Arafura Resources Ltd

Nolans Project Section 14A Notification

June 2019

Arafura is proposing changes to the assessed Nolans Project, and submits this document as notification of the proposed alterations, in accordance with Clause 14A of the Environmental Assessment Administrative Procedures.

Figure 3-1 Mine site revised general arrangement

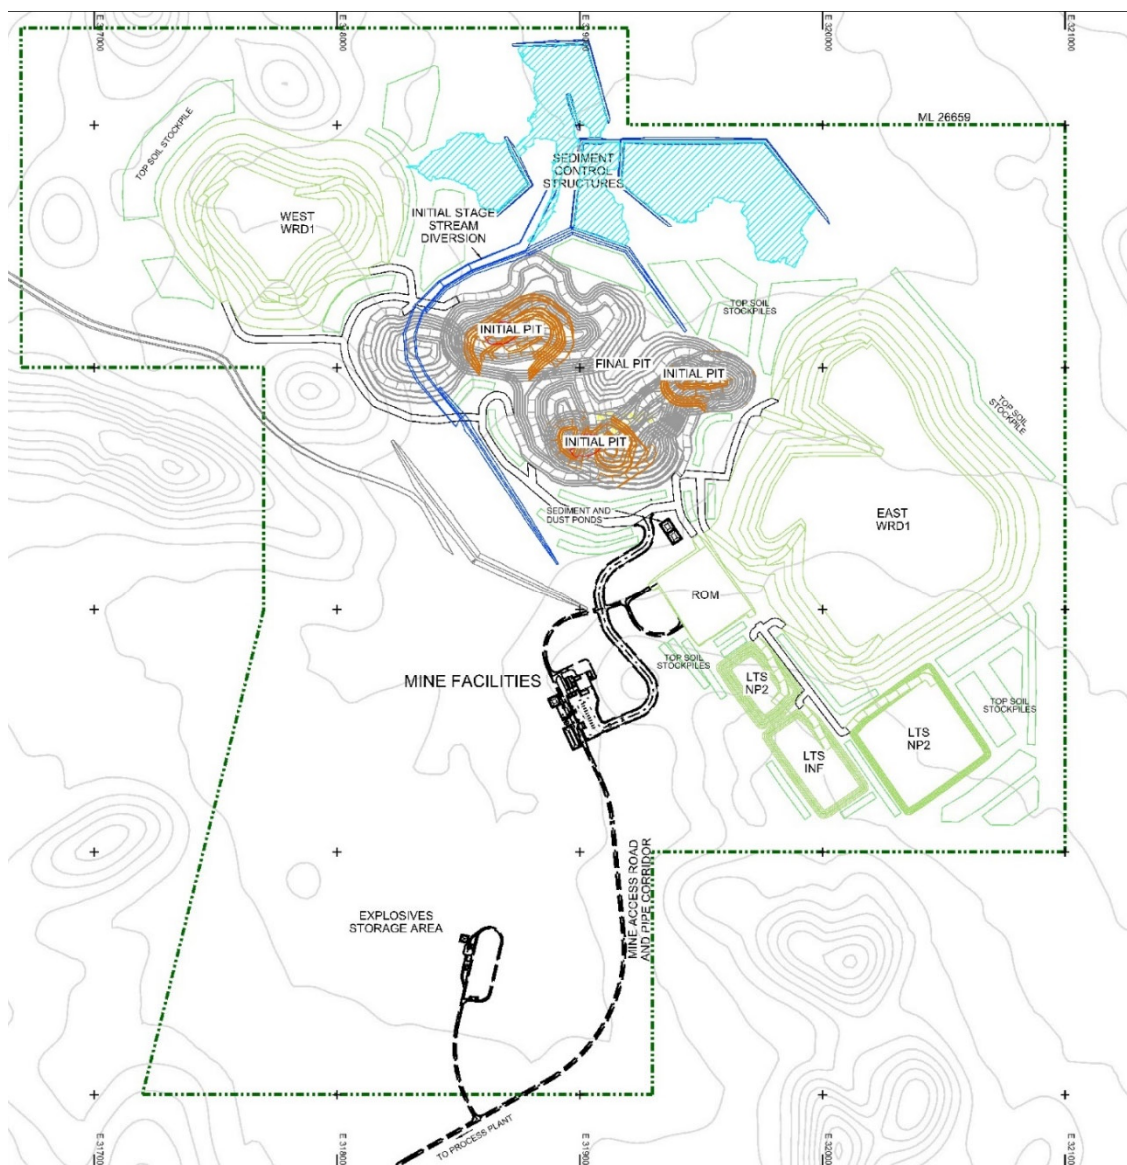
The Revised mine site general arrangement is contained in in Figure 3-1 and Appendix A, Drawing 801-140-A5001-050. Key changes include the removal of tailings storage facility from the mine site and relocation to the processing site as part of a combined tailings and residue storage facility.

Mining operations will be 24 hours/day. Overburden and waste rock will be deposited in 2 purpose-constructed WRDs over the LOM (Figure 3-1). This is a reduction from the 6 WRDs proposed in the Assessed Project.

Low grade ore will be stockpiled in a long term stockpile at the mine site. The long term stockpile will store lower grade and non-PAPL preferred ore for future processing (see Figure 3-1). The revised Project has the long-term stockpile (LTS) located adjacent to WRD1 East which will enable simple future rehabilitation of this ore, if a decision is made to not process this ore. The LTS will be built on a compacted layer of material and rehabilitation would involve covering the ore with a 2m capping of benign waste rock to minimise erosion and provide shielding as with the waste rock dumps.
